UNITED STATES PATENT AND TRADEMARK OFFICE

APPLICATION NO.	FILING DATE	FIRST NAMED INVENTOR	ATTORNEY DOCKET NO.	CONFIRMATION NO.
09/935,151	08/22/2001	Gregory Alan Steube	20518/13 (S-8475)	9252

Office Action Summary

DETAILED ACTION

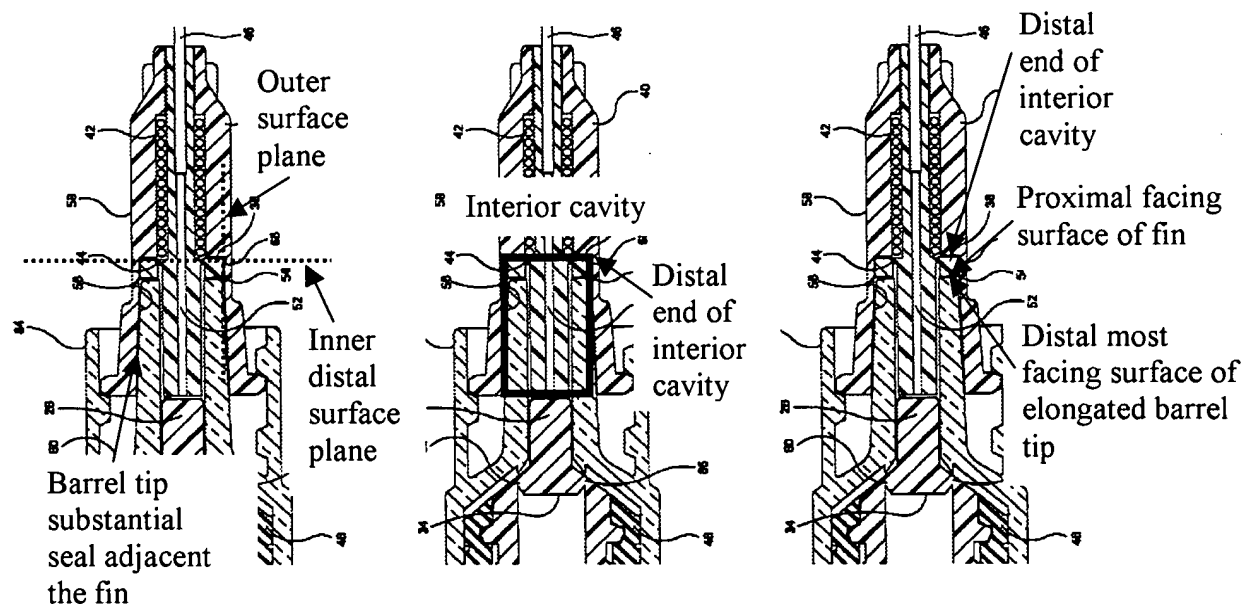
Claims 1-7, 10-18 and 21-26 are rejected under 35 U.S.C. 102(b) as being anticipated by Carter et al (USPN 6,010,486). Regarding claims 1, 5 and 21, Carter discloses a needle assembly that includes a needle hub (40) defining an interior cavity (see middle figure below), a distal end (see middle figure below), and one non-sealing rigid fin (54) having an outer surface plane that intersects an interior surface plane of the needle hub (see left figure below) that defines the

interior cavity. The fin is considered rigid because the cross hatchings for the fin used in figure 6 indicate that the material used is plastic. In order for any type of plastic material to maintain the shape of the fin shown in figure 6, the property of the plastic material used would necessarily have to include some degree of rigidity. The fin is considered non-sealing in that the prior art specification does not reference the element (54) as a gasket, o-ring or seal. The fin extends longitudinally a fixed distance from the distal end of the interior cavity to a proximal facing surface (see right figure below). The proximal facing surface engages a distal most facing surface of an elongated barrel tip (see right figure below). The needle hub also includes a needle support (tubular portion of 38 not including fin) which extends through the interior cavity. A barrel (20) has a proximal end and a distal end with the barrel tip at the distal end which is received within the interior cavity. See figure 2 and middle figure below.

Regarding claims 2-4 and 22, the barrel tip is elongated and extends from the distal end of the barrel (see figures above). The interior cavity has an annular configuration, see figure 2 in conjunction with figure 6. The barrel tip forms a substantial seal adjacent the fin in that the outer

surface of the barrel tip is fastened to the interior surface (56) of the needle hub (40). See above figures. Additionally, even though the prior art does not specify that the fastening of the needle hub to the barrel tip forms a seal, the claim language only recites a substantial seal and to seal is defined as “to close or make secure against access, leakage, or passage by a fastening or coating” (see <http://www.merriam-webster.com/cgi-bin/dictionary>). In this case, the connection of the needle hub (40) to the barrel tip closes off access to the barrel tip by the fastening or connection of the two elements and thereby reads on the limitation of a “substantial seal”.

Regarding claims 10-17 and 23-26, the needle hub (40) includes a hub skirt (see flange on proximal end of needle hub (4) in figure 6). The interior cavity (see above middle figure) is annularly defined between the perimeter of the hub skirt and the interior axis of the needle support (38). The needle support (38) has a needle cavity (52) having a portion of the needle disposed therein. See figure 6. As shown in figure 6, the needle cavity and interior cavity are coaxial. Since the cavities are coaxial, they are also substantially parallel since they extend in the same longitudinal direction. As shown in figures 6-7, the barrel receives a plunger (30) that is configured to engage a proximal opening of the needle support (38).
